Richland Creek WMA- ADA Evaluation

WMA- Richland Creek, Streetman TX, ADA Evaluation

Accessibility Evaluation

Inspection Date: 07/08/2022

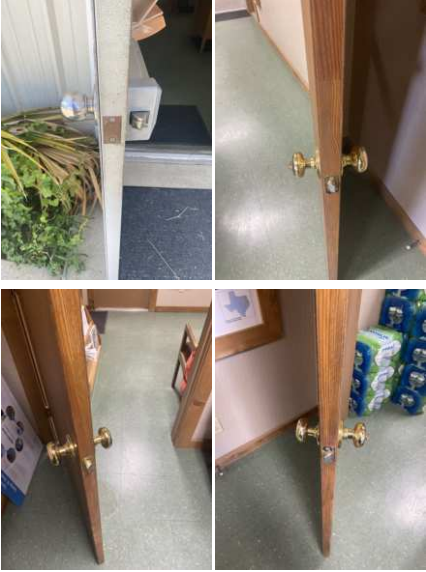
Finding Number	Area Description	Finding	As Built	Recommendation	Citation	Photos	Figure
4	Exterior of Property (Public): HQ Parking Lot (1 Space) 1 Unlabeled - Access Aisle (Unlabeled Stall)	The minimum vertical clearance at the accessible parking stalls and/or the access aisle has not been provided. Parking spaces, access aisles and vehicular routes serving them shall provide a vertical clearance of 98 inches minimum.	Over hang of front door cover in access aisle and below 80"		https://www.access-board.gov/ada/#ada-502_5	2012 TAS Section: 502.5 2010 ADAS Section: 502.5 2015 ABAAS Section: 502.5	 
5	Exterior of Property (Public): Pavilion Parking Lot (1 Space) 1 Unlabeled - Accessible Stall (Unlabeled)	The stripe is missing at the left side of the left parking stall which identifies its border. Vehicle spaces shall be marked to define the width, and shall have an adjacent access aisle.	Border is missing on (L) side of parking stall. ISA Markings are beginning to fade and will need upkeep soon		https://www.access-board.gov/ada/#ada-502_2	2012 TAS Section: 502.2 2010 ADAS Section: 502.2 2015 ABAAS Section: 502.2
